2019
OXFORD ELEMENTARY SCHOOL
UNIFIED SCHOOL DISTRICT 358
 319 East College Street, Oxford, Kansas 67119

DRAWINGS ISSUED		
NO.	DATE	ITEM ISSUED
8	9/19/19	ADDENDA 2
7	8/19/19	ISSUED FOR BIDS
6	8/19/19	40% REVIEW
5	7/5/19	REVIEW
4	6/24/19	REVIEW
3	5/6/19	REVIEW
2	4/27/19	REVIEW
1	4/08/19	REVIEW

A1.5

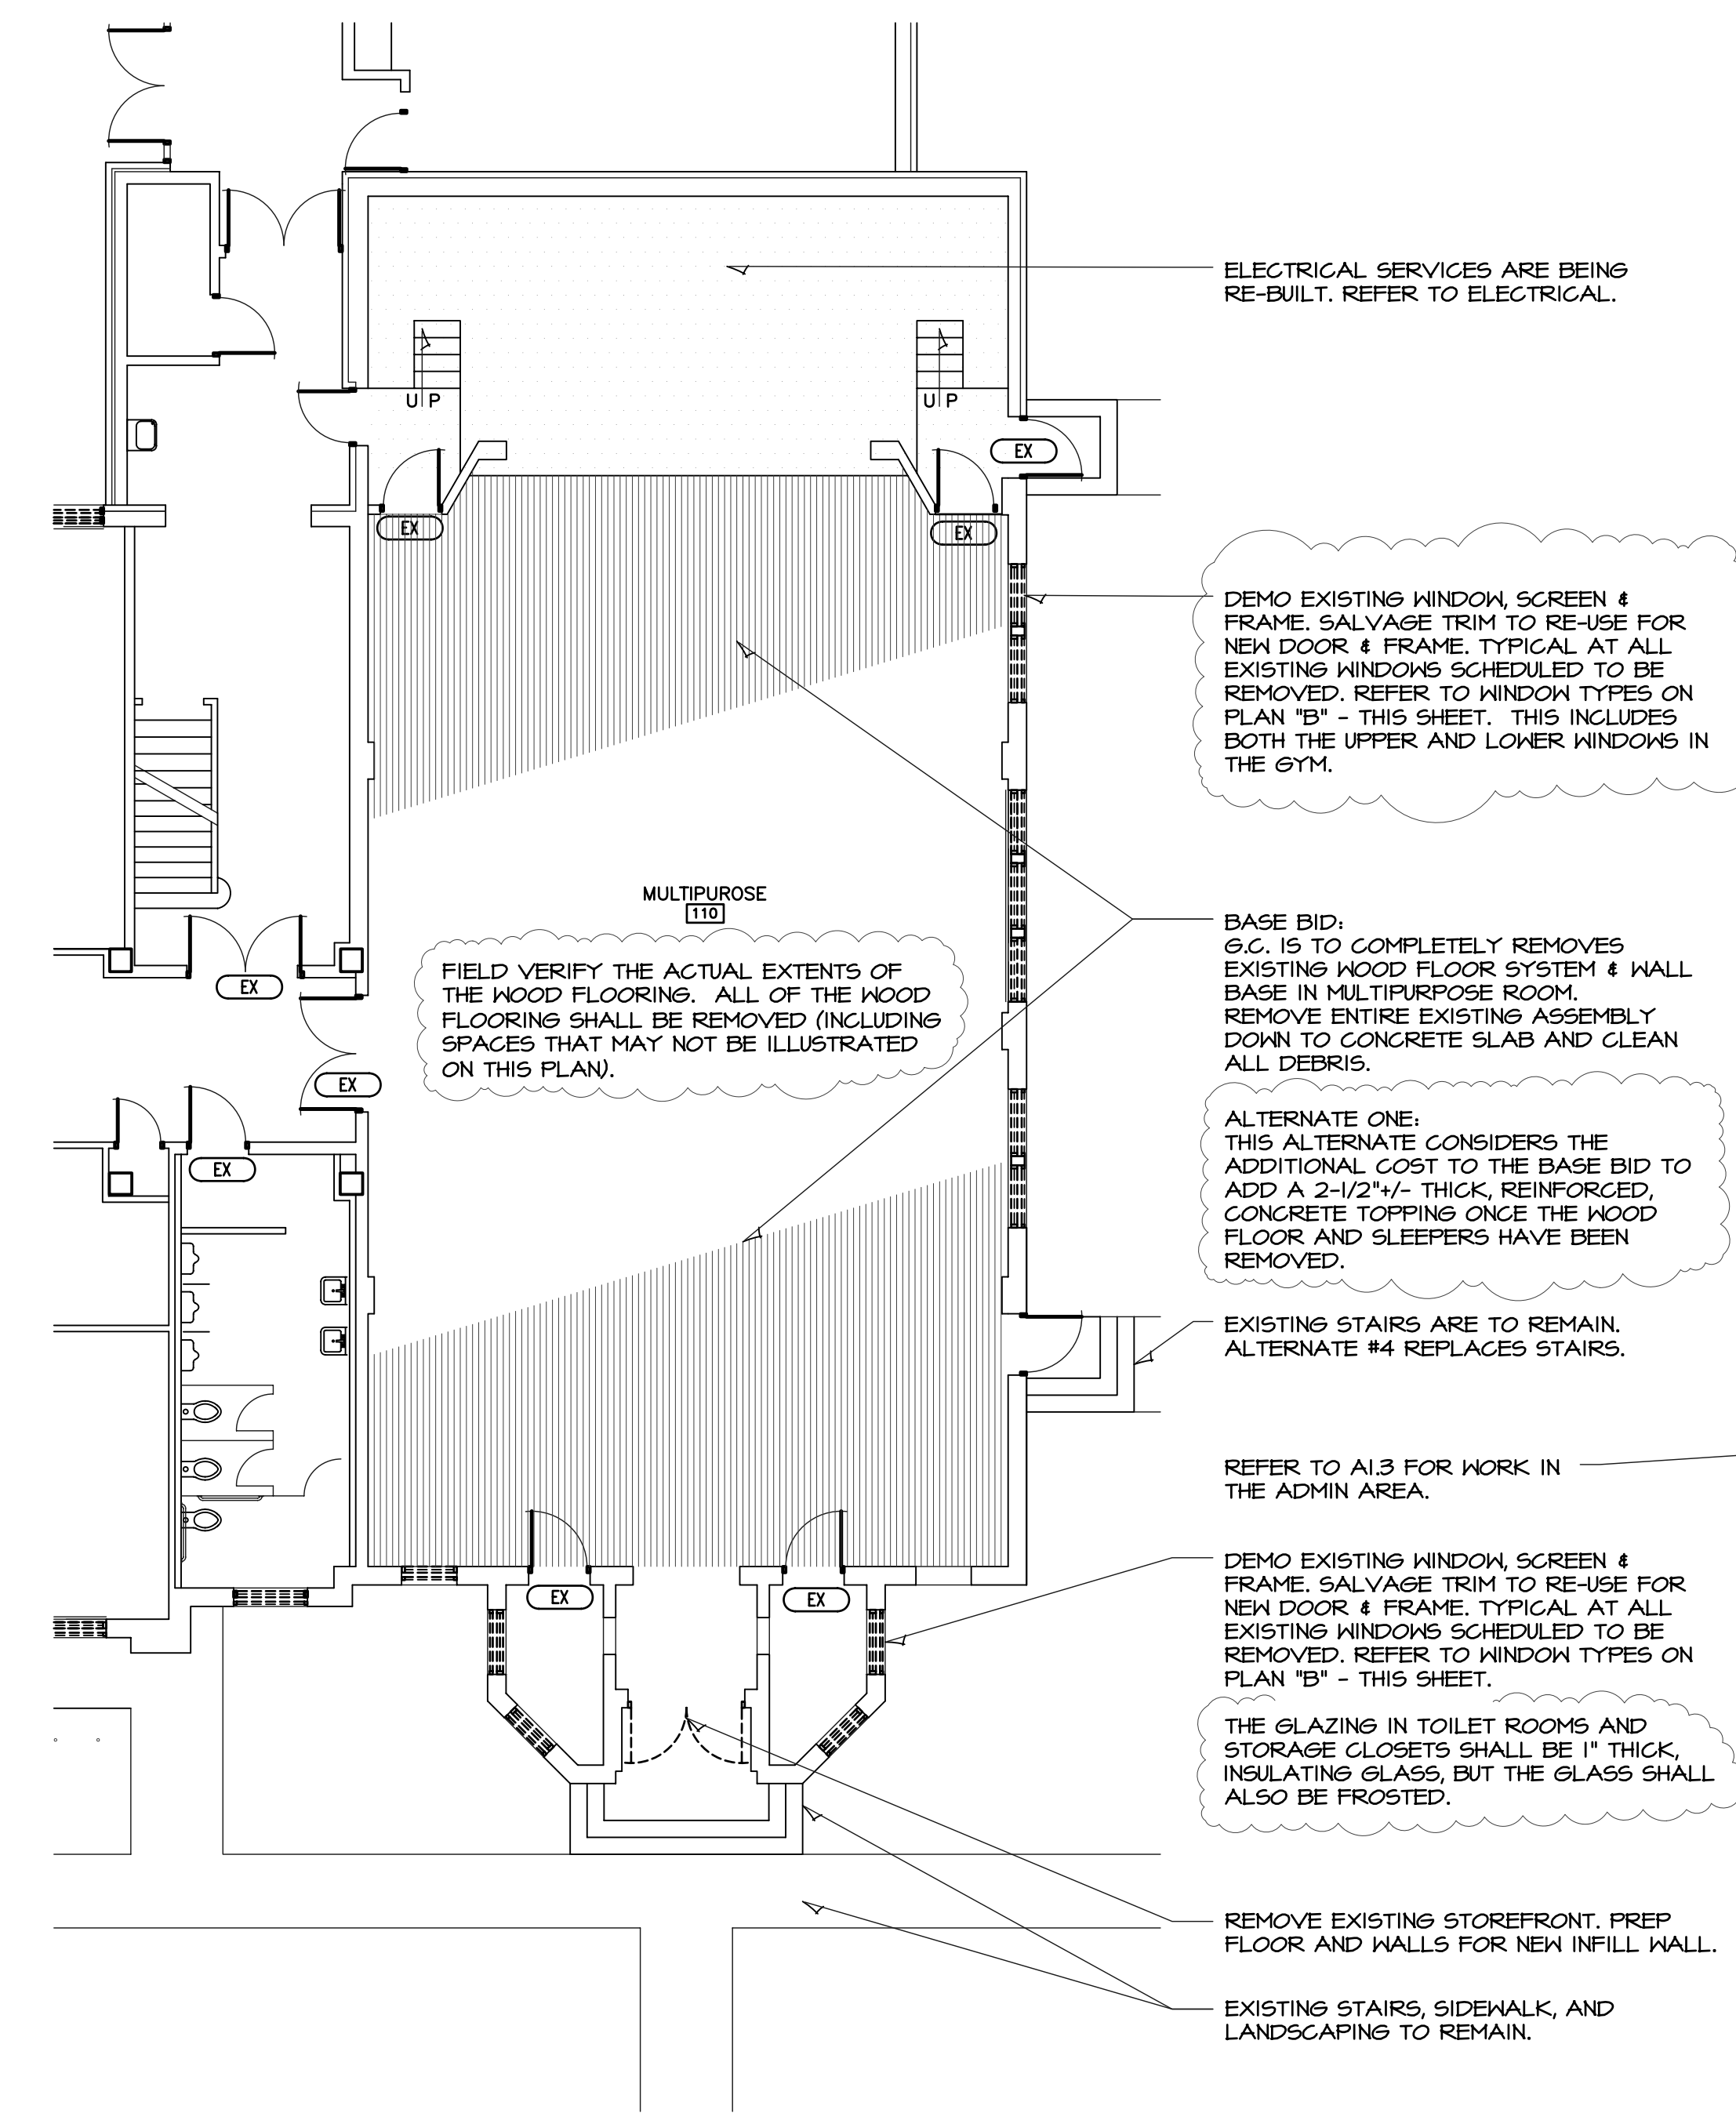
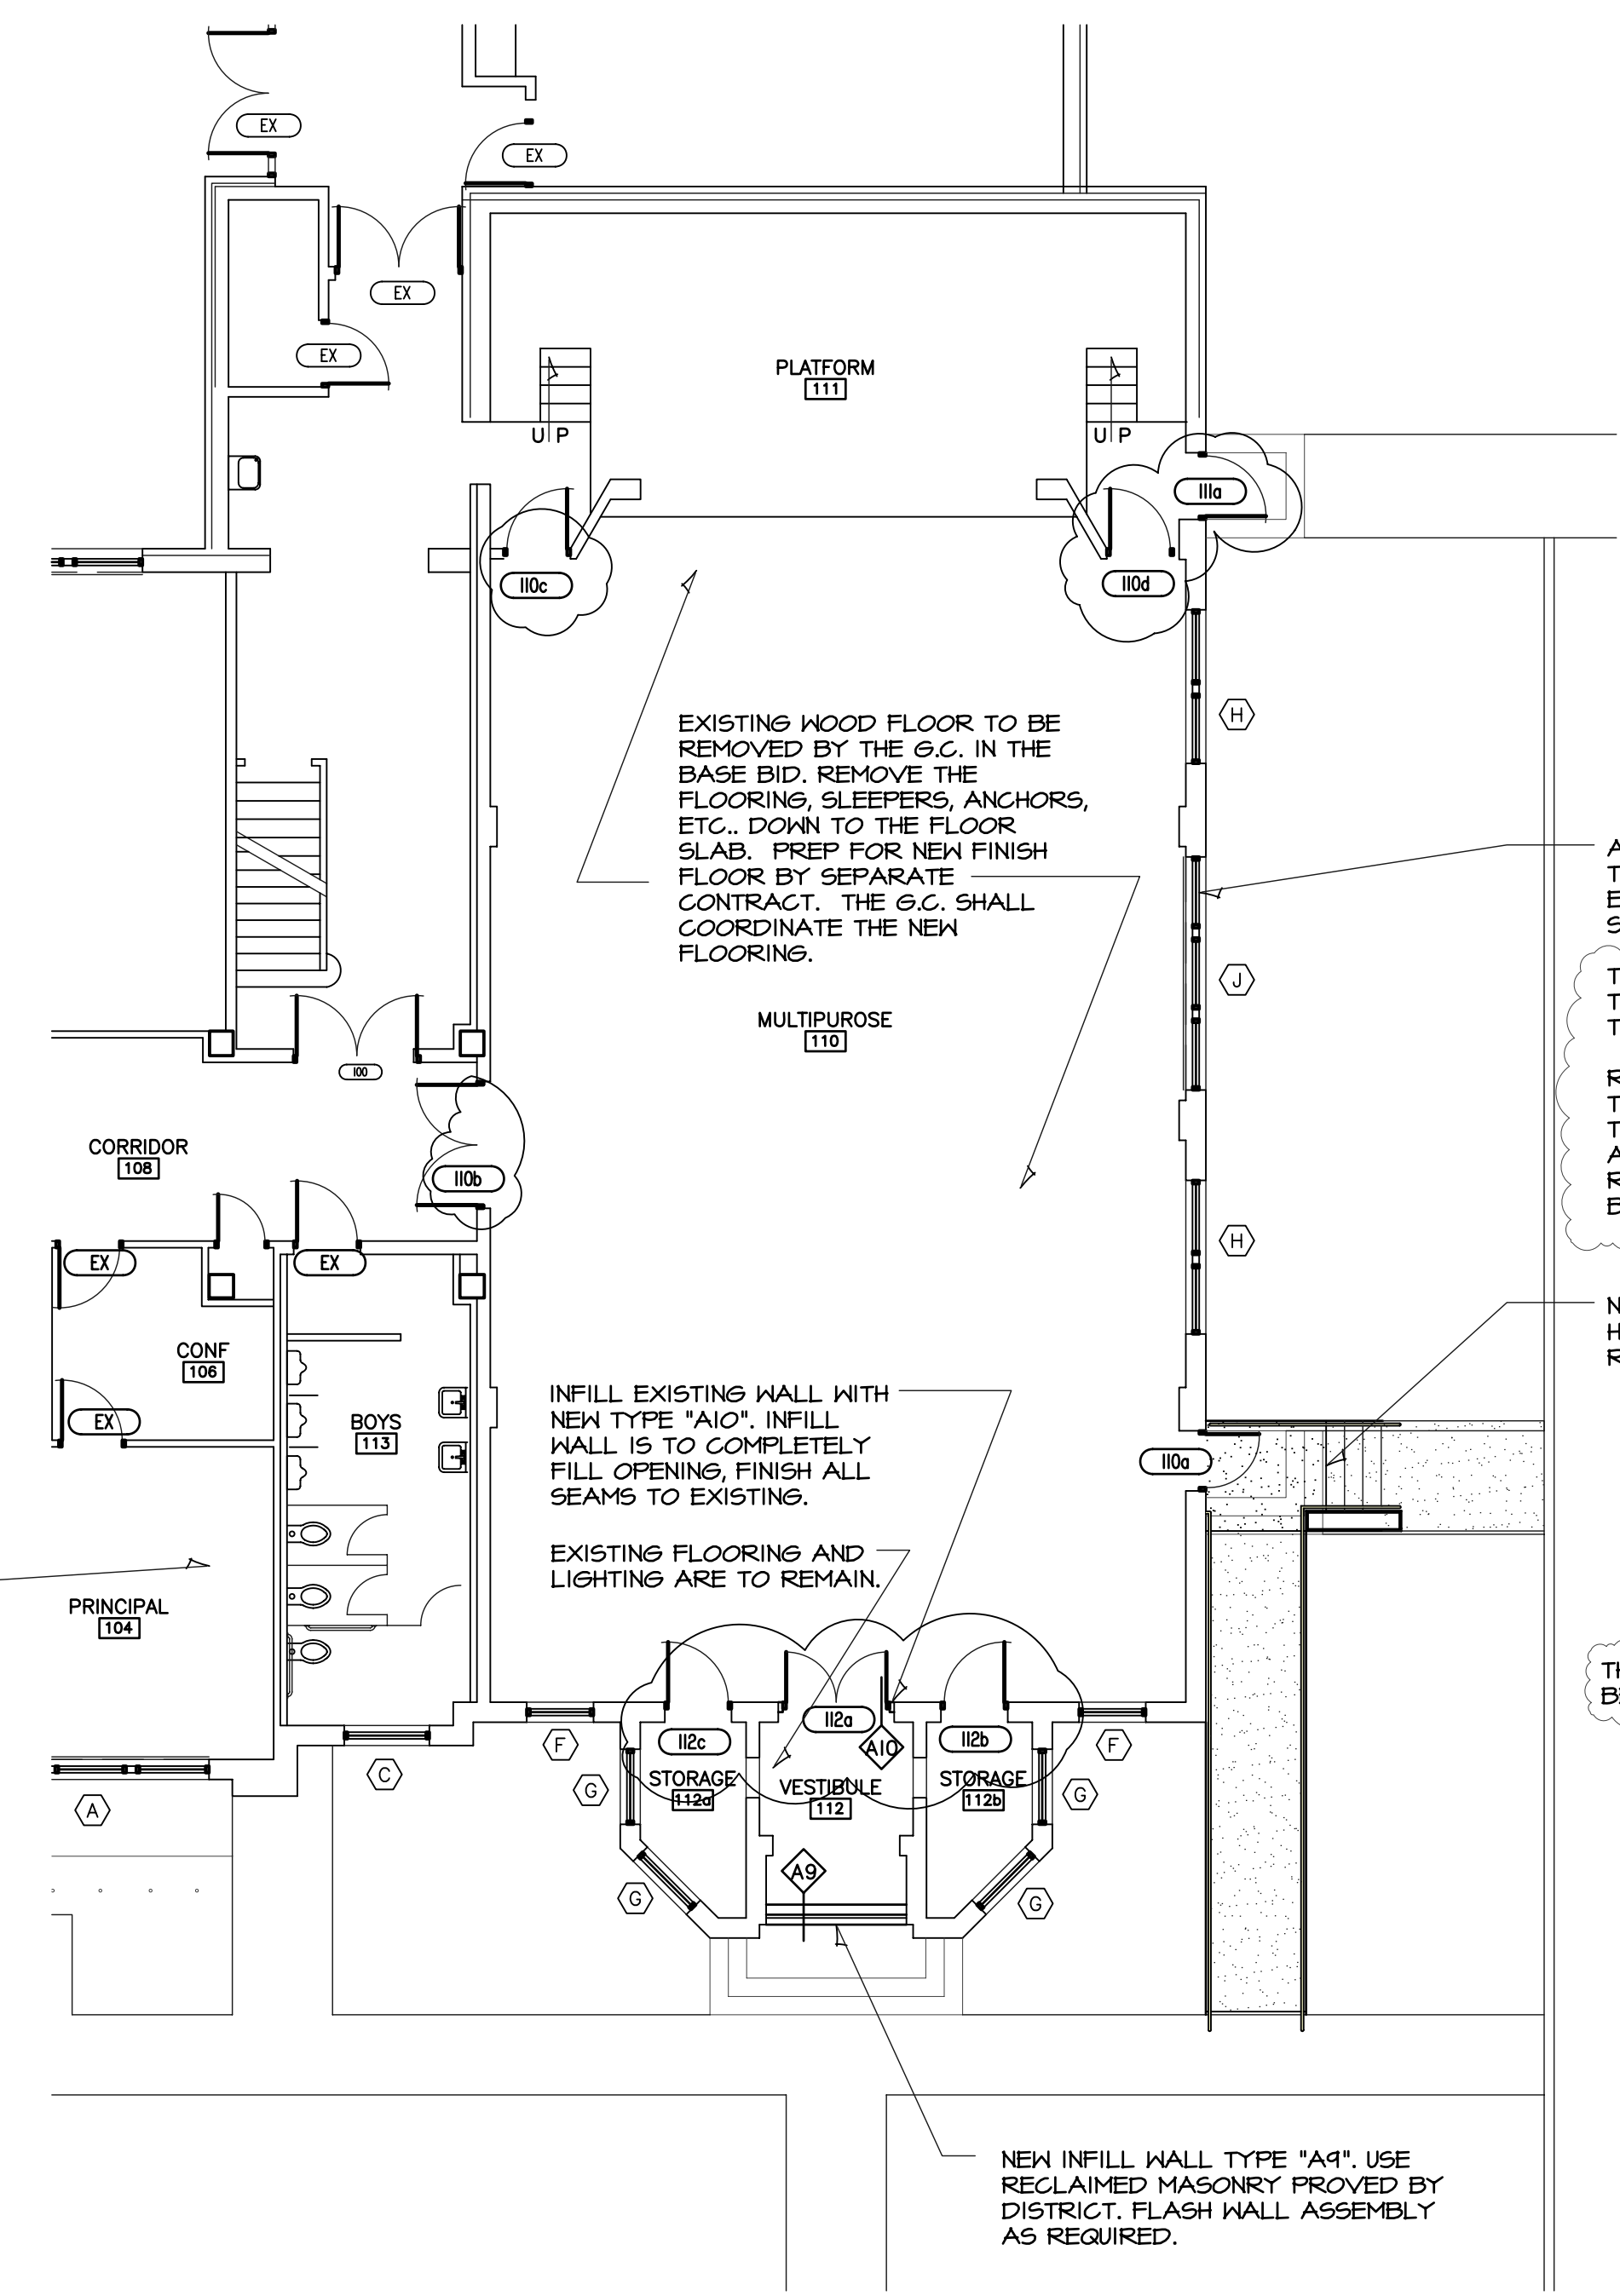
THE DOOR ID INDICATORS HAVE BEEN CORRECTED.
